DATE: 08.29.2019
TO: ProTrak
FROM: Mitesh Baxi
Traffic Engineering

■ **THE MINI PEARL [TRC Plan Review #2]**

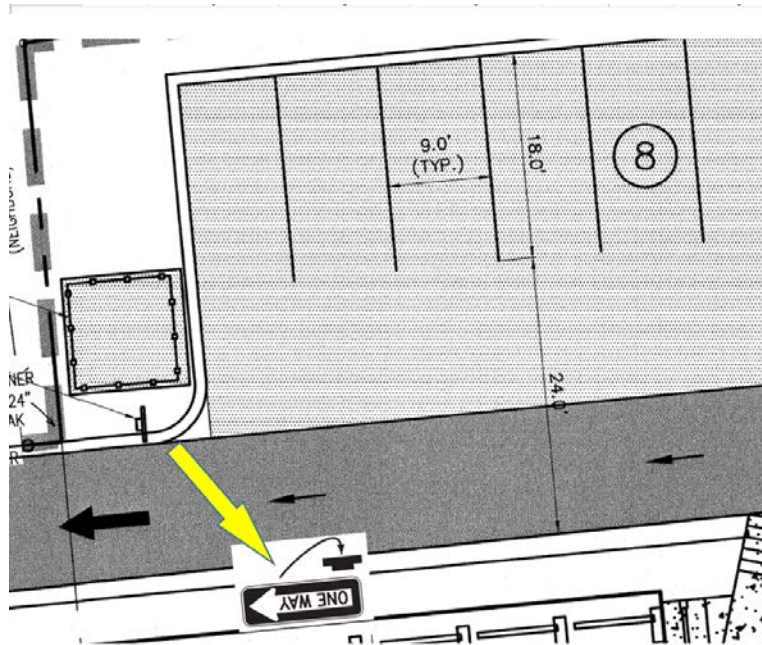
1. If installed, ONE WAY signs shall be placed parallel to the one-way street [MUTCD]. With the reference to this project, it may be applicable to one-way drive aisle. The arrow of the One-way sign shall be parallel to the direction of the drive aisle. Below image is for your reference only.
